AGENDA ITEM REPORT

ITEM: Review and discussion of Site Plan Application by 9201 West LLC to construct a 6 unit, 3- Story Multi-Family Development to be located at 9201 West Bay Harbor Drive. Enclosed are the Site Plans and the Staff Report prepared by Town Planner Michael Miller.

Subject: **Site Development Plan Application**
 Bay Harbor III Townhouses -5 DU Townhouse Complex
 9201 - 9241 West Bay Harbor Drive
 Bay Harbor Islands Acct. No. SPR22-00002
 MMPA Account No. 01-0702-1114

MMPA recommends the Development Review Committee (DRC) **DEFER** action on the proposed Site Development Plan application at this time to allow the applicant's design team to address the listed comments. The submittal package has several design / Code violation issues, some of the plans are inadequate or missing and a few other items need to be corrected.

4 ROOF DECK PLAN
SCALE: 1/4" = 1'-0"

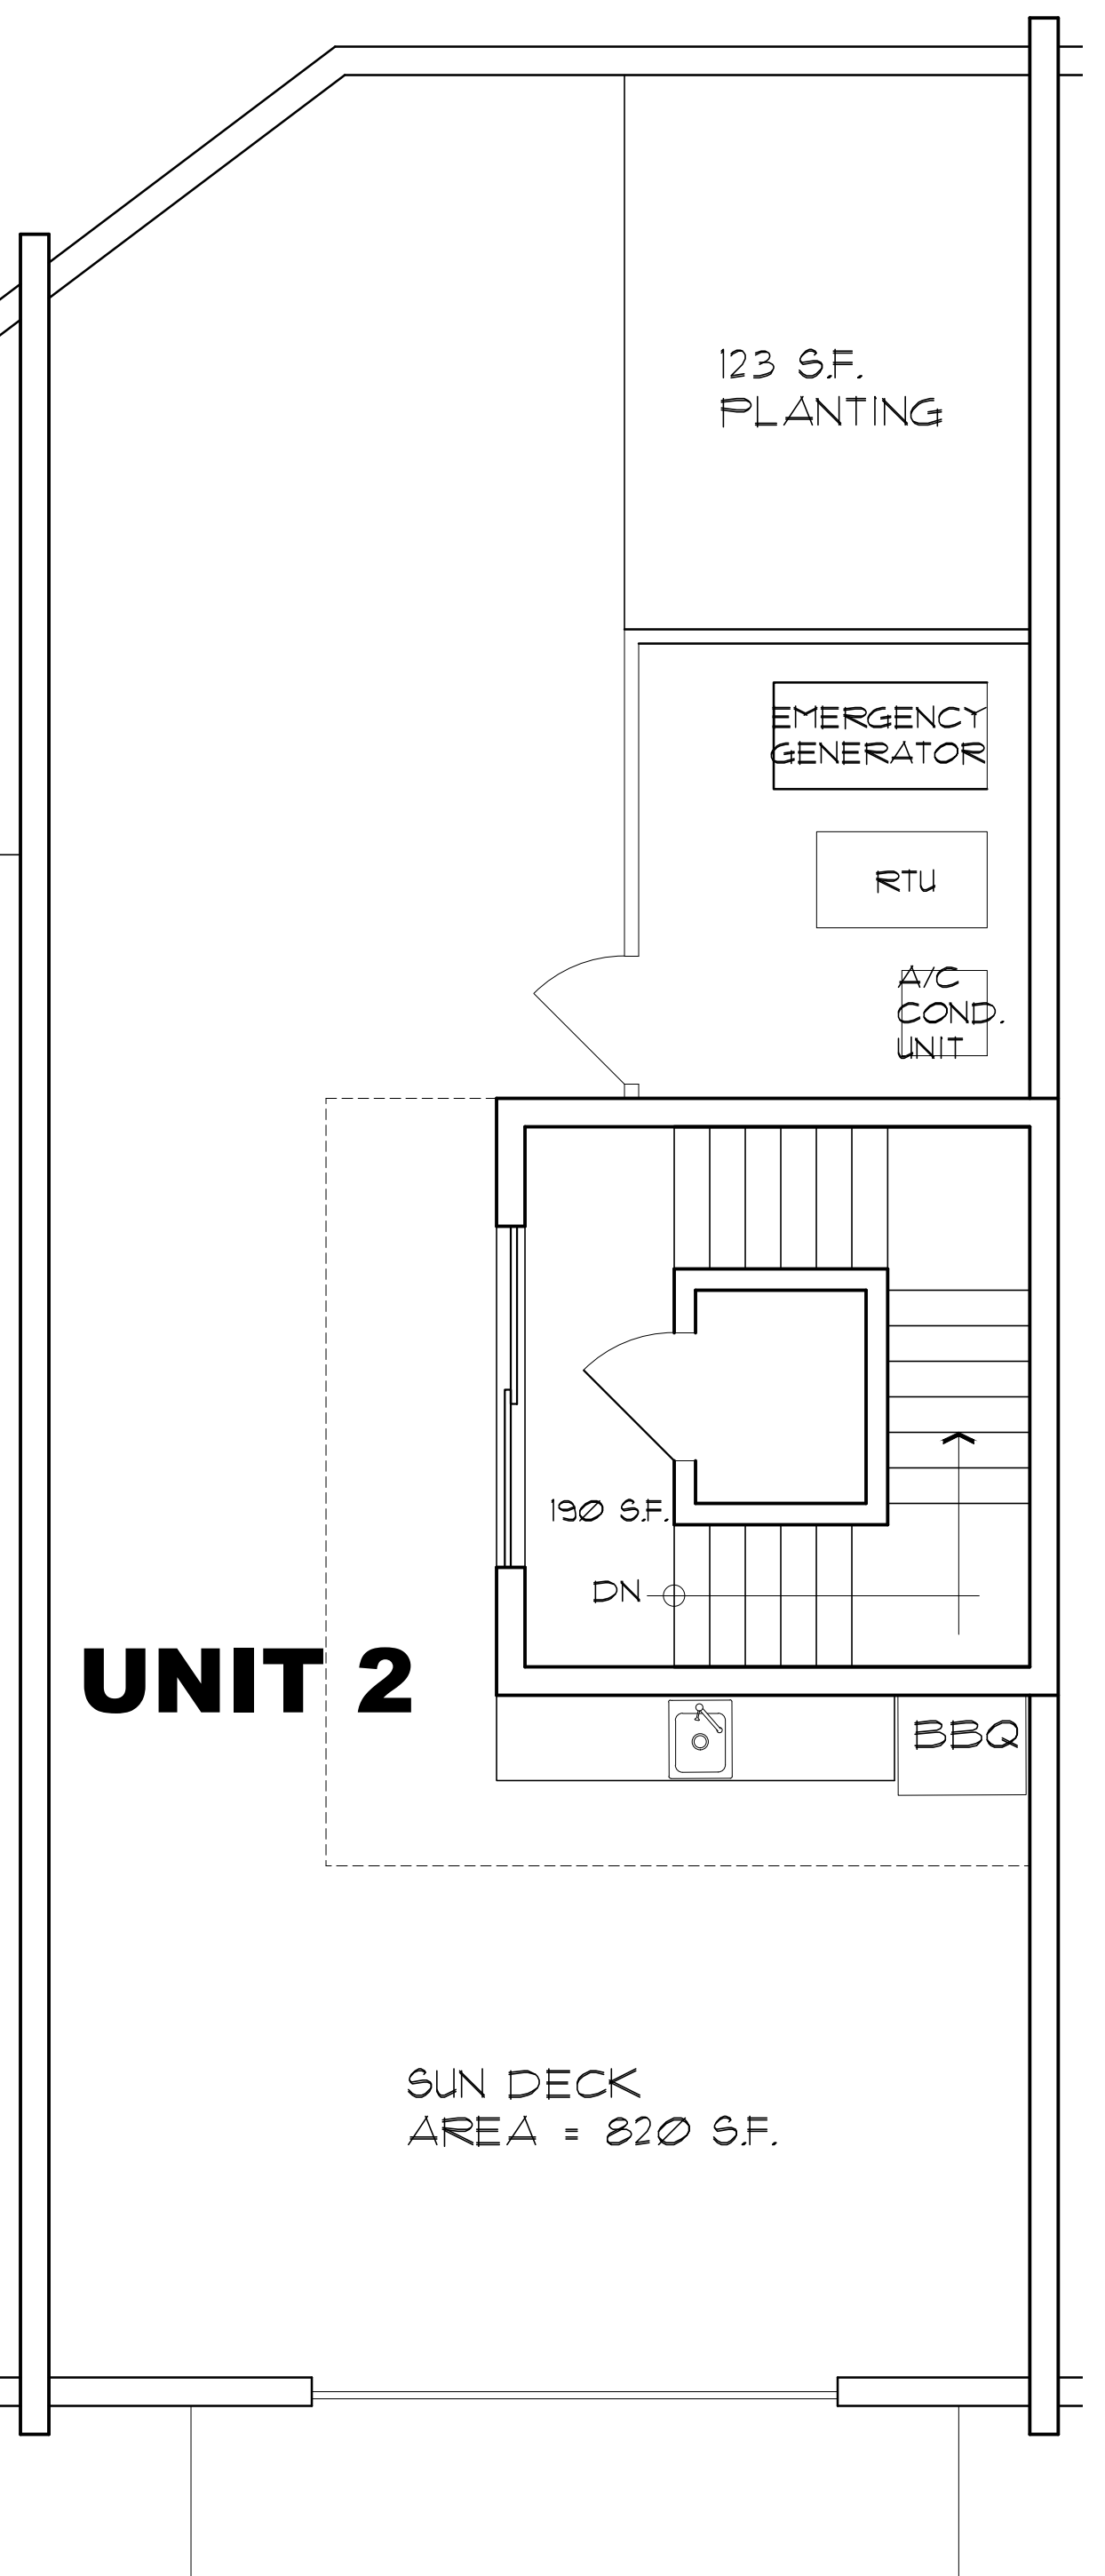
15. On Sheet A-5 Roof Deck Plan a bathroom is shown. Please provide a detail showing the height of the bathroom. Also provide a detail / information on the proposed screening around the roof A/C units. Please provide the height, screen material and color.

4 FENCE & ENTRY TRELLIS ELEVATION
A-119
SCALE: 1/4" = 1'-0"

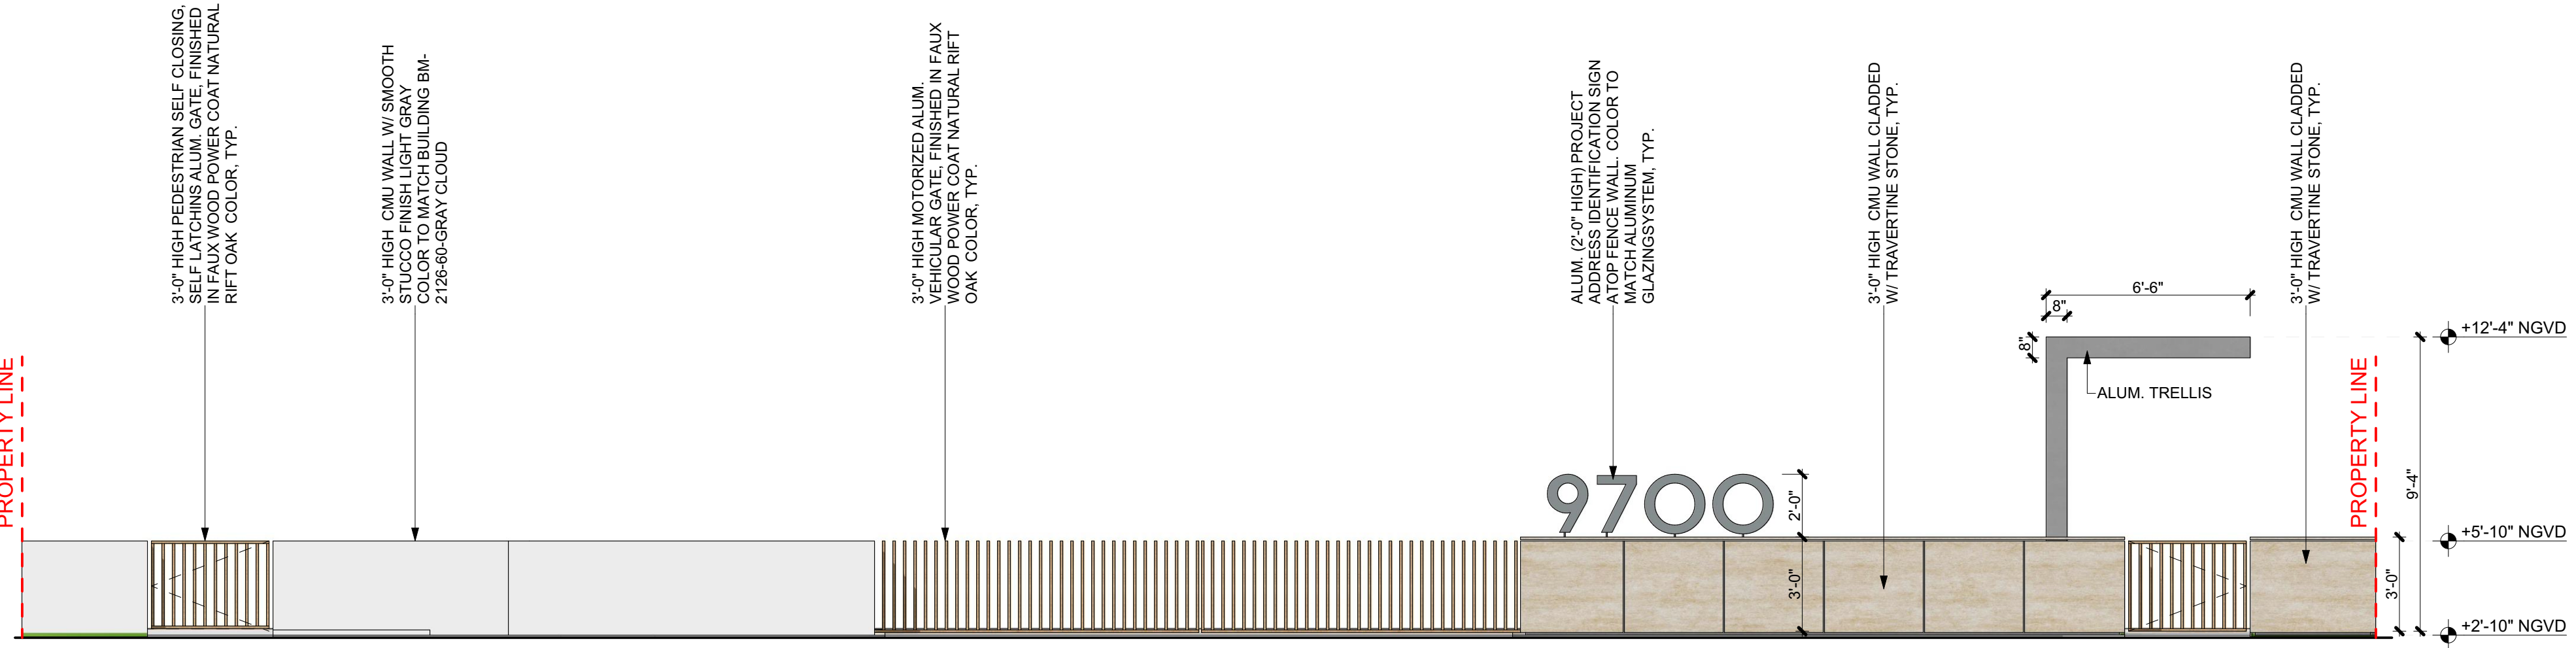
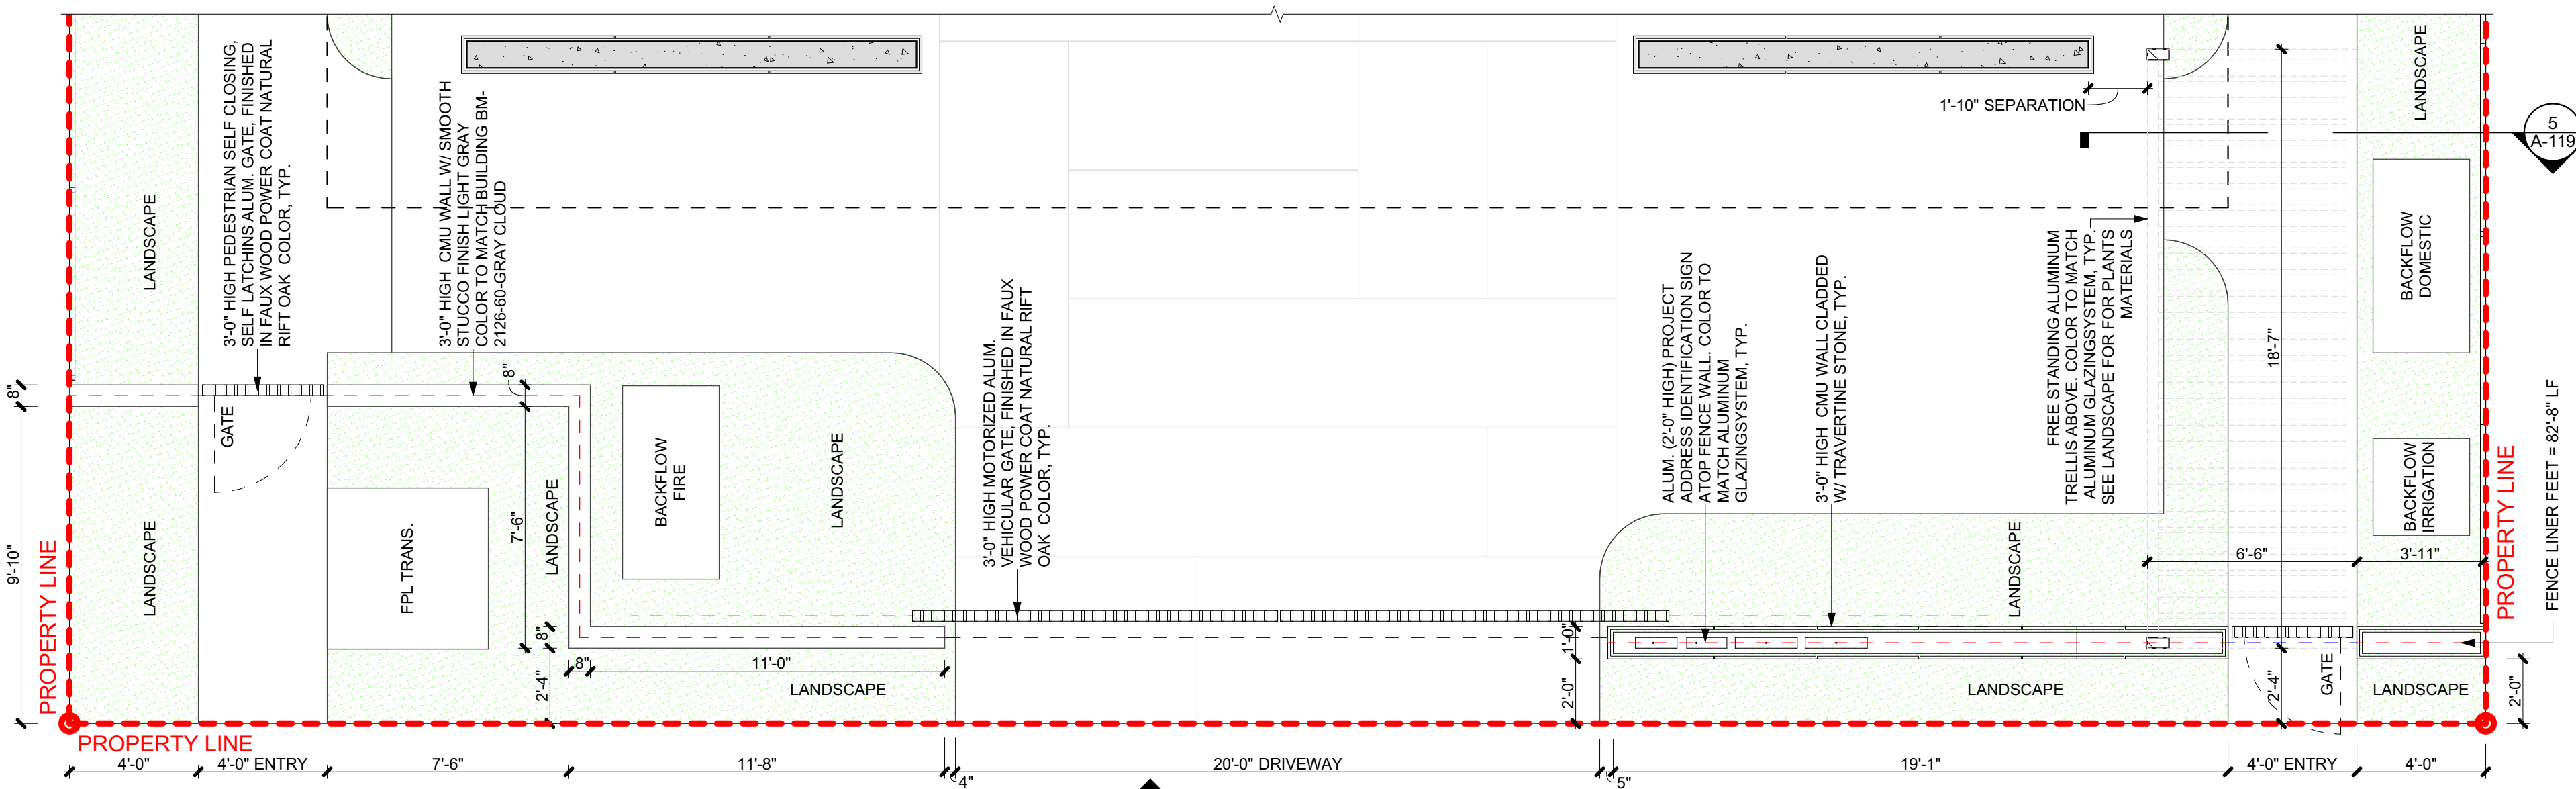
- 1) **MMPA Previous Comment #7** - On Sheet A-103 and new Sheet A-119 trellis structures have now been added to the site layout – one “square-shaped” metal trellis located in the north side setback at a building entry point, and another large “rectangular-shaped” metal trellis over the front yard walkway from the street to the building entry. Sec. 23-12(15)(e)(iv) allows the DRB to approve trellis structures in “side and rear yards” only – not front yards. However, Sec. 23-12(15)(e)(vii) allows the DRB to consider “covered pedestrian walkway” structures, including front yard areas. If the plans were modified to rename the front yard structure to a “covered pedestrian walkway” this would seem to meet the Code allowance. It is suggested to help meet Code the roof of such structure be solid or include additional cover (clear / shaded) in between the open areas shown for rain / sun protection.

A-7

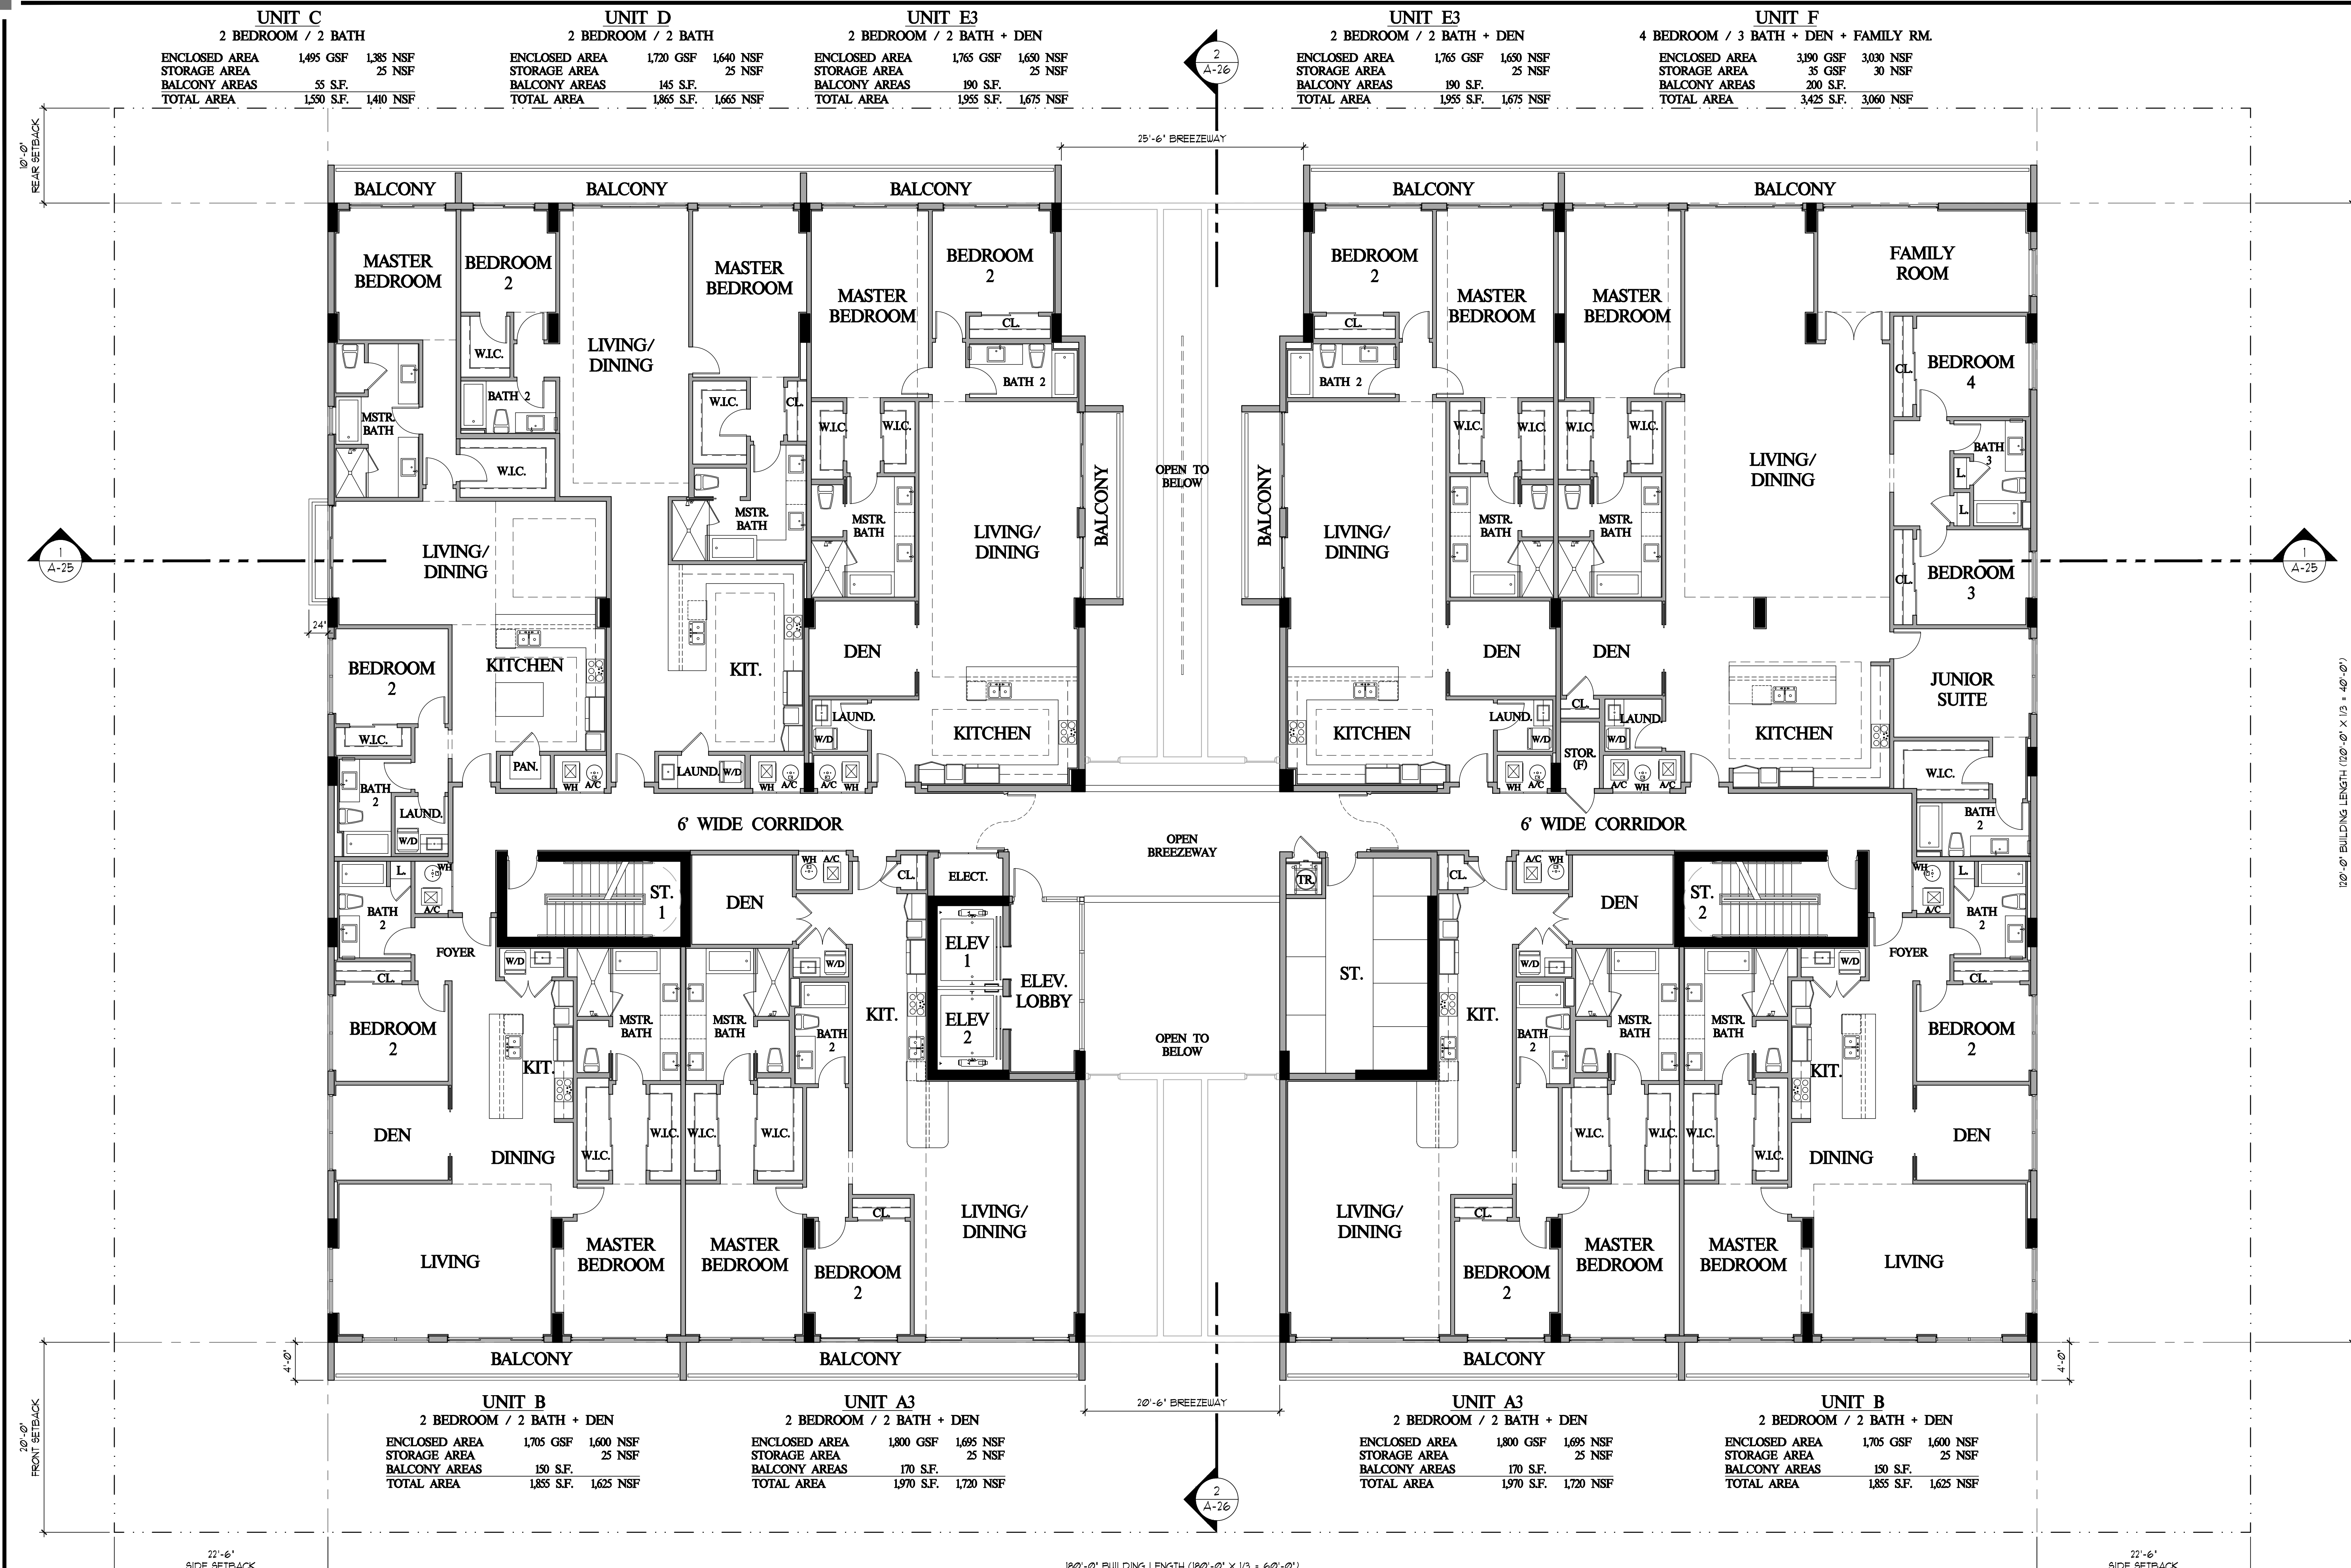
- 1) On Sheet A-7 the plan shows that the widths of the required landscape strips along 100th Street are less than the 10' required by Town Code, and some are not dimensioned at all. Sec. 24-16(c)((3)(5) of the Code requires a minimum 10' landscape strip width between a front property line and any interior paved areas (driveways / parking spaces). Miami-Dade Chapter 18A is the countywide Landscape Code for Miami-Dade County. The minimum front yard landscape strip width in M-D County is 7'. Local governments are allowed to have more restrictive criteria – and we do as an upscale community. The plans show some landscape widths at 8' next to guest spaces which the Town's DRB has approved. However, the landscape strip adjoining the lobby drop-off area is not dimensioned – but scales to only 4.5'+/- in width. The Town cannot / will not approve that narrow of a landscape strip width. Suggest redesigning the project to make the building less intensive / make the building envelope smaller / reduce the driveway width / relocate the guest spaces & lobby driveway toward the building. The Town's streetscape appearance takes precedence over the developer's desired building intensity. Dimension each landscape strip shown. Curbing is not part of the landscaped strip width. If the landscape strip dimensions are less than 10' provide a justification explaining the rationale for the request for the Town to consider.

- 2) On Sheet A-7 the plans show a landscape width of 2'-4" between the east property line and a walkway by the solid waste enclosure. Per Sec. 23-12(15) the minimum width between a walkway and an interior property line is 3'. Revise the plans to meet minimum Code criteria.

- 3) On Sheet A-7 the plans show a Transformer Vault room at elevation 6.0' NGVD. We believe this floor elevation must be above FEMA BFE + 1' FBC freeboard. Bldg. Official to confirm.
